| Project | IEEE 802.16 Broadband Wireless Access Working Group < http://ieee802.org/16 > | |
| Title | Rate based bandwidth request mechanism | |
| Date Submitted | 2006-11-07 | |
| Re: | IEEE 802.16j-06/027: "Call for Technical Proposals regarding IEEE Project P802.16j" | |

Figure 43a Relationship between $req_i(t)$, $dout_i(t)$, and $dout_i(t)$

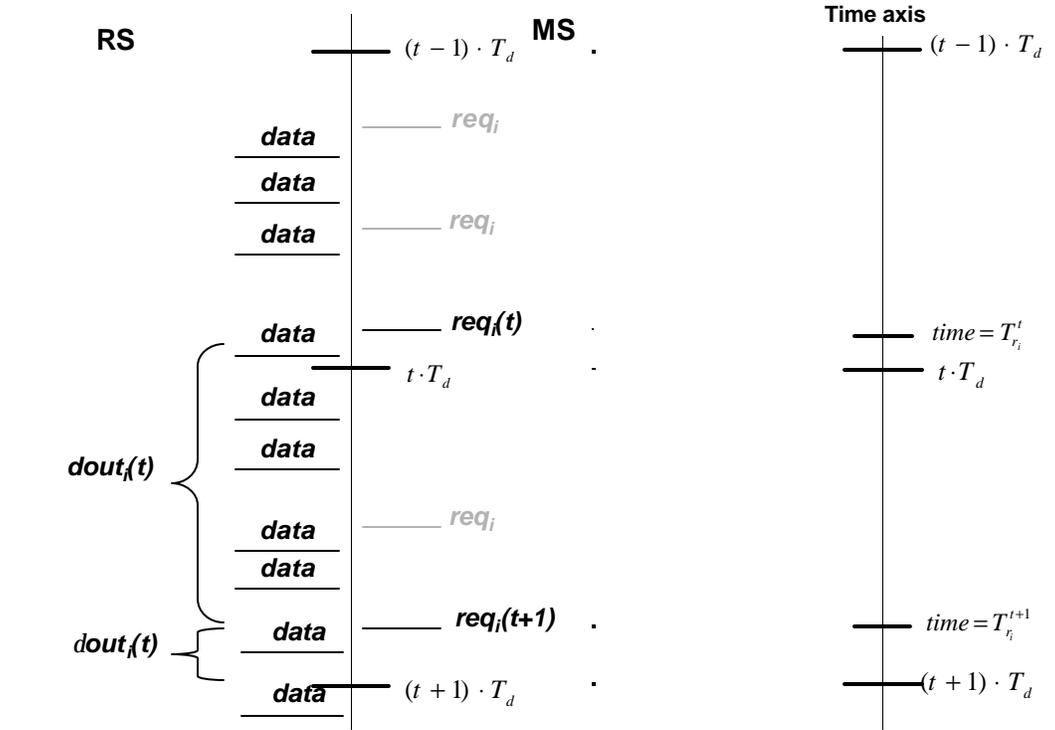
At each check point of period T_d , for instance at the time $t \cdot T_d$, an RS starts to count the amount of data from connection i and resets the variable $dout_i(t)$ to be zero. $dout_i(t)$ is a temporary variable recording the amount of data from connection i received between two BRs. Upon reception of a data packet from connection i , an RS adds the byte number of the new received data packet to $dout_i(t)$. Upon reception of a BR header from connection i , the RS adds the value of $dout_i(t)$ to $dout_i(t)$ and reset the value of $dout_i(t)$ to be zero.

The amount of data of connection i , $din_i(t)$, entering an SS during the interval between two BR headers $req_i(t)$ and $req_i(t+1)$ can be derived using Equation (8b):

$$din_i(t) = req_i(t+1) - req_i(t) + dout_i(t) \quad (8b)$$
